Re: NCIRT Review and USACE Approval of the NCDMS Lyon Hills Mitigation Site / Wilkes Co./ SAW-2018-01784/ NCDMS Project # 100085

MITIGATION PLAN

Lyon Hills Mitigation Site

Subject: Mitigation Plan Report and Construction Plans
Lyon Hills Mitigation Project, Wilkes County
Yadkin River Basin HUC 03040101
USACE Action ID No. SAW-2018-01784/DWR No. 2018-1274 v1

1.21

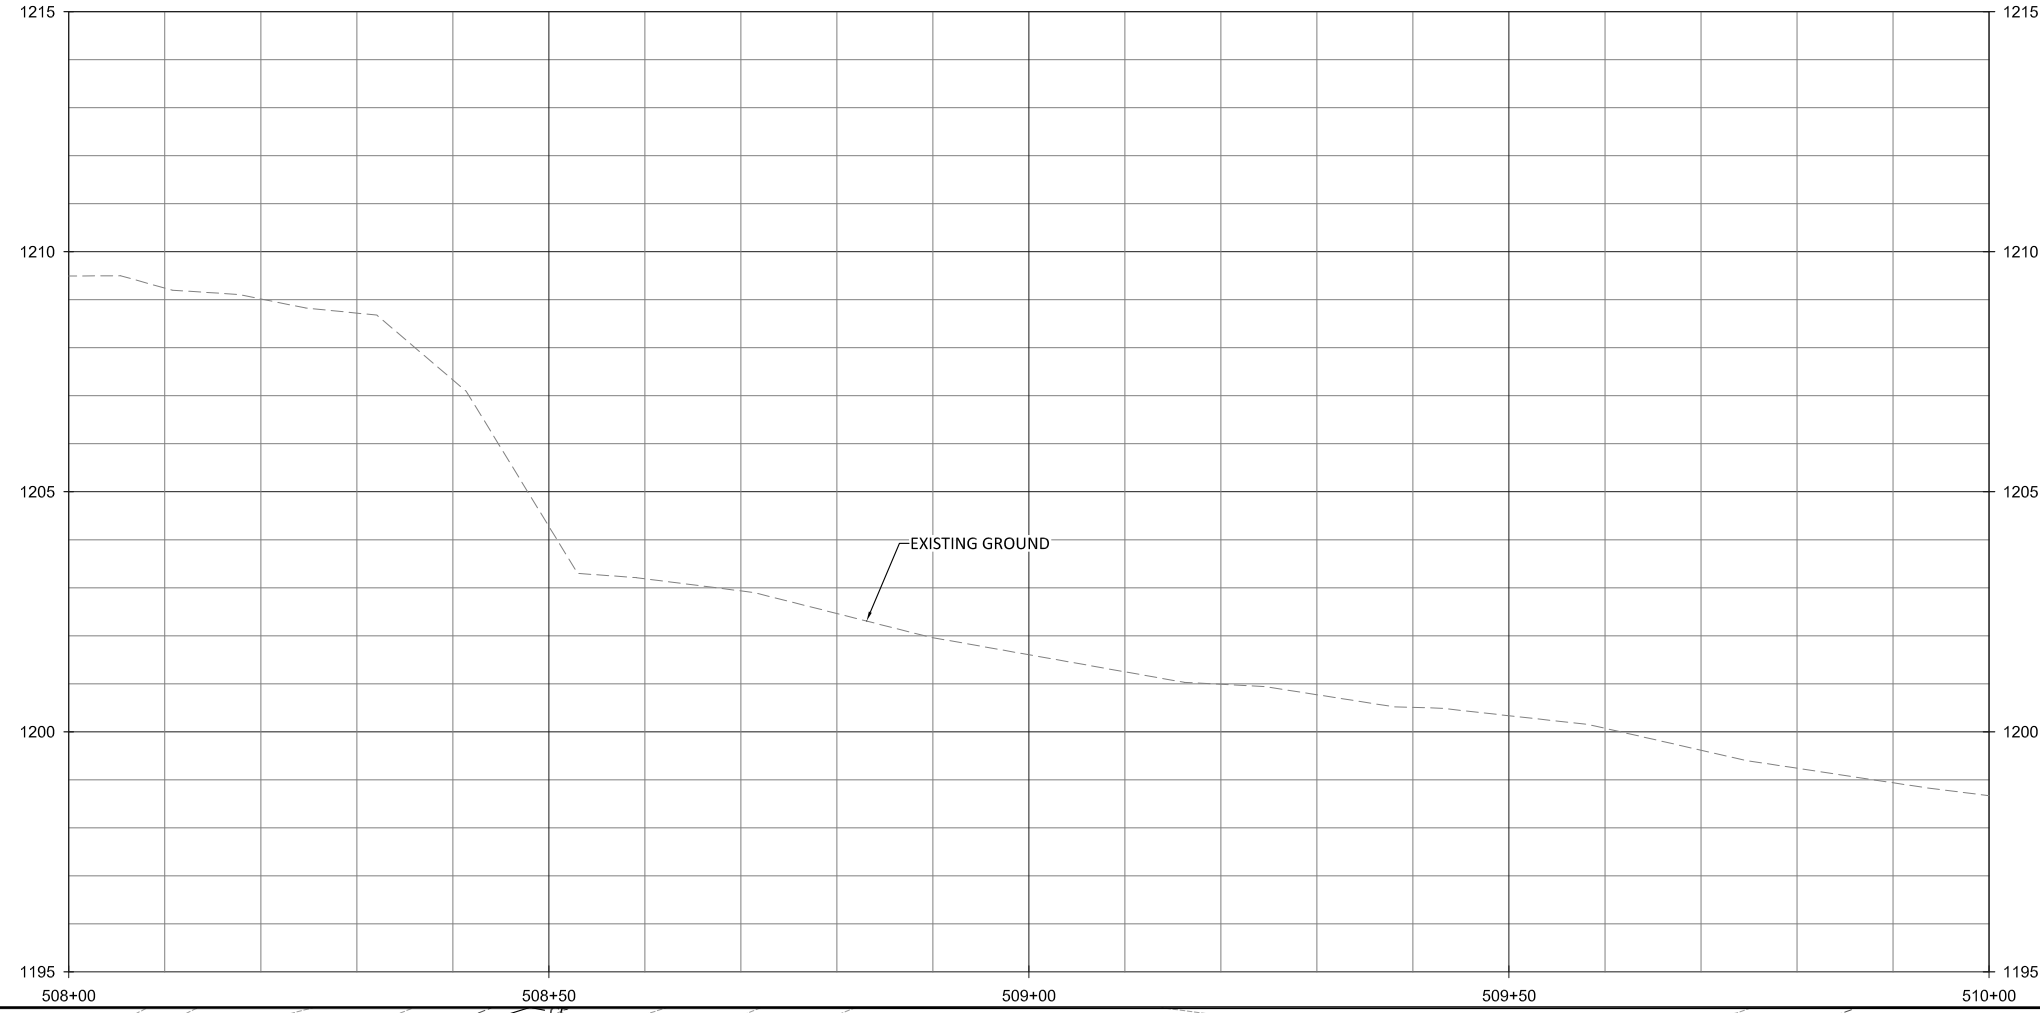
18. Sheets 1.21-1.23 – Please assess the banks along UT3 Reach 2 and Reach 3 that have callouts to "repair trampled stream banks per Engineer's direction" and include specific proposed actions/features in the final design plan.
